Figure 18: The two traffic management options for the closure of Wynyard Lane as provided in the PPR. Option 1 is on the left and Option 2 is on the right.

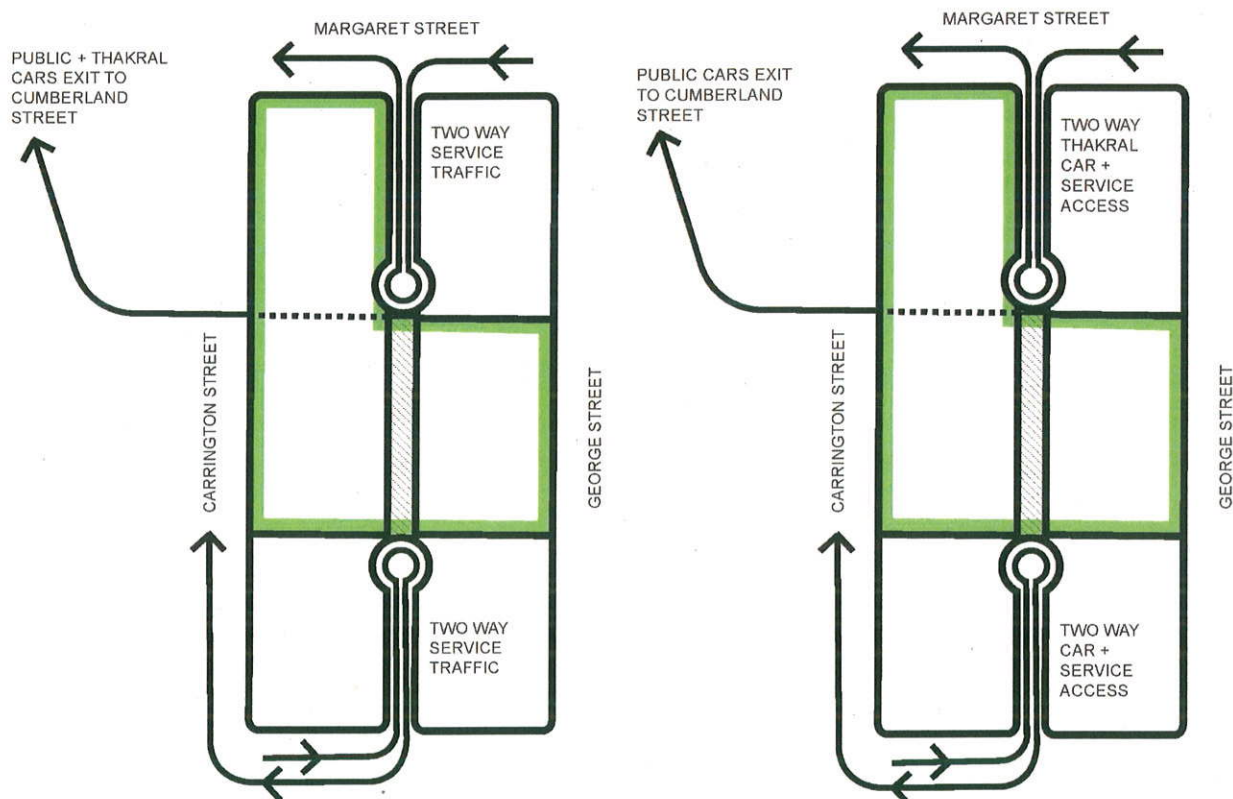
The Department, Council and Transport for NSW each raised concern over the proposed treatment of Wynyard Lane as a shared zone through the station concourse, given the heavy pedestrian flows and potential pedestrian / vehicular conflicts. Council further recommended that Wynyard Lane should only be a pedestrian link as it passes through the concourse and also that a working party be formed to resolve the final configuration for the issues associated with Wynyard Lane prior to the approval of any Concept Plan.

In its submission to the PPR the Council considers that insufficient detail has been provided to resolve technical issues such as swept paths, intersection performance, turning areas and carriage width to allow two way traffic.

The PPR addresses this concern by providing two possible design options, each of which involves the closure of Wynyard Lane to through-traffic for all but emergency vehicles (**Figure 18**). These options are as follows:

The Department considers that both options outlined above will remove the pedestrian / vehicular conflicts through the concourse and provide a more appropriate pedestrian environment. Also the supplementary traffic report prepared by Halcrow concludes that this may be done without significant adverse effects to the local road system. Transport for NSW however prefer a scenario in which vehicles using the tenant car parking do not exit via the former tram tunnels as this land is leased from the State and may be used for another purpose in the future. Option 2 as described above will address this concern as cars will exit via Wynyard Lane.

The Proponent has identified that the technical issues associated with the proposed lane as outlined above can be addressed and have provided further details showing space for turning areas for trucks (8.8 metre MRVs). Council's recommendation to have this matter fully agreed prior to determination of the Concept Plan is not considered necessary as it has been demonstrated to an adequate level of certainty that the proposed changes can be achieved. It is recommended that the final design details for this matter be resolved as part of any future application for the project stage involving the construction of the pedestrian concourse across Wynyard Lane.

Figure 19: Section through the site showing the compatibility at the interface point of the proposed concourse levels east of Carrington Street with the existing Wynyard Station concourse levels to the west of Carrington Street (on the left shown in red).

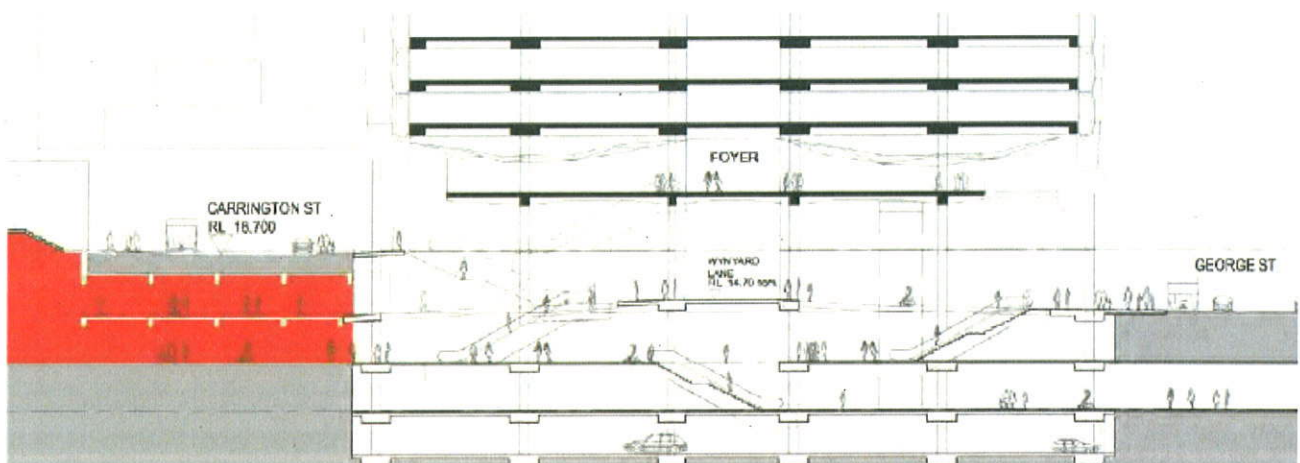
The Department also sought further information addressing design compatibility at the interface between the east and west of Carrington Street and considers that the key interface compatibility aspects are:

The proposed concourse levels connect directly into the existing main station concourse (**Figure 19**). These new connections match the levels of the existing upper and lower levels of the concourse. The Proponent acknowledges that the design at this interface point remains indicative only and will be subject to detailed design resolution as part of any future application for these works, and is reflected in the Proponent's revised Statement of Commitments.

The Department considers this response to be adequate as it demonstrates that the Concept Plan is capable of being compatible with the existing station concourse west of Carrington Street and will allow for pedestrian connections to be made regardless of any final design for the concourse and station upgrades west of Carrington Street.
